L & H PLACE SUBDIVISION

APPLICATION NUMBER 2 DATE May 7, 2015

REQUEST Subdivision

DETAIL SITE PLAN

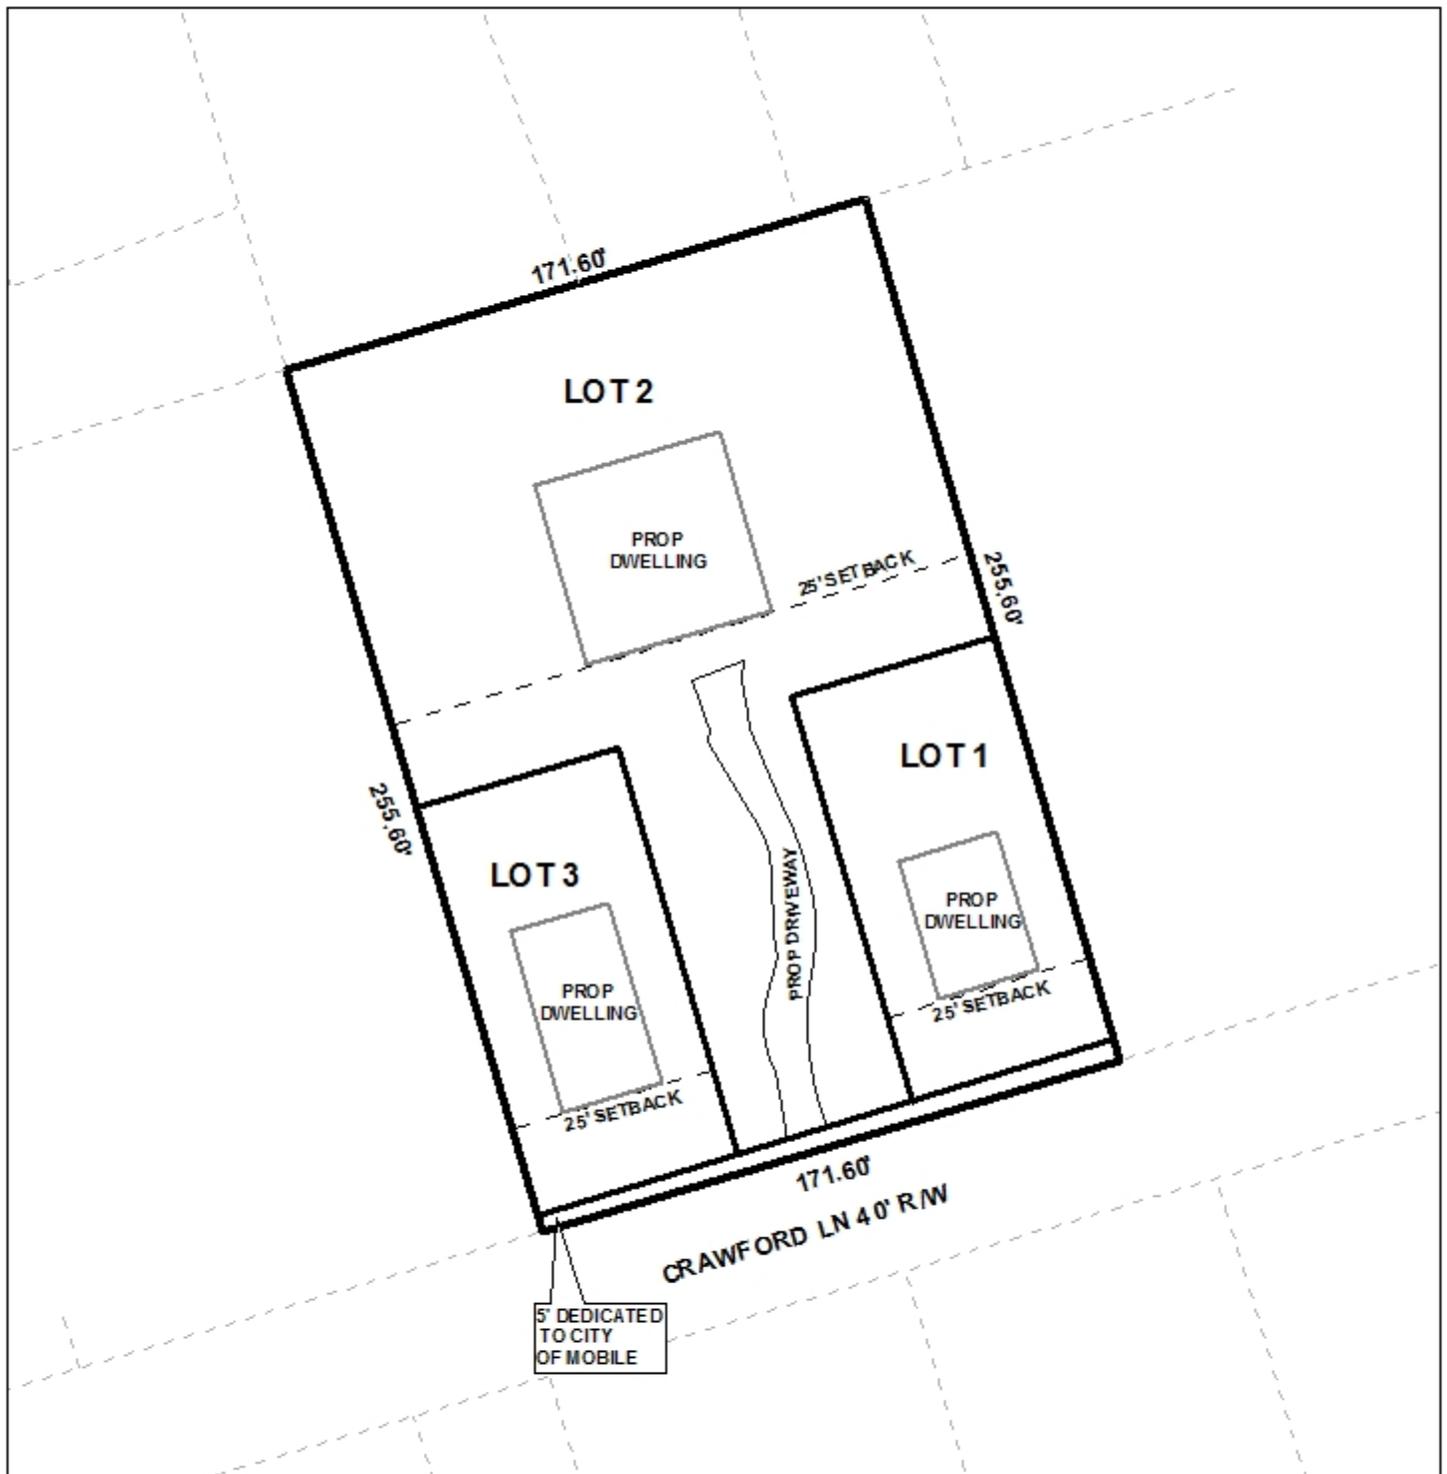
This application was heldover from the March 5th meeting to allow the plat to be revised to a two-lot Subdivision which would be more in harmony with the surrounding neighborhood. A revised plat was submitted but still proposing three lots. It was revised to indicate the street frontage dedication along Crawford Lane and associated adjustment of the depth of Lots 1 and 3 to compensate for the area loss due to dedication. The proposed dwellings and one internal driveway were also added to the plat.

It should be noted that the revised plat does not address the compatibility and flag lot issues, and is virtually unchanged from the original. As justification for retaining the three-lot configuration, the applicant submitted evidence of two other flag lot and two irregularly-shaped properties in the area. However, staff research indicates that, as per the GIS data base and County Tax Records, all four of the subject properties cited are metes-and-bounds and none were created via any Subdivision. Therefore, they would not be considered as justification for the approval of the subject application and staff recommends denial for the following reasons:

- 1) the flag lot is not in harmony with the surrounding lots in the neighborhood;*
- 2) none of the criteria to justify the Subdivision as per Section V.D.1. of the Subdivision Regulations has been presented; and*
- 3) examples of properties cited as evidence of flag and irregularly-shaped lots in the area are metes-and-bounds and none were created via Subdivision approvals.*
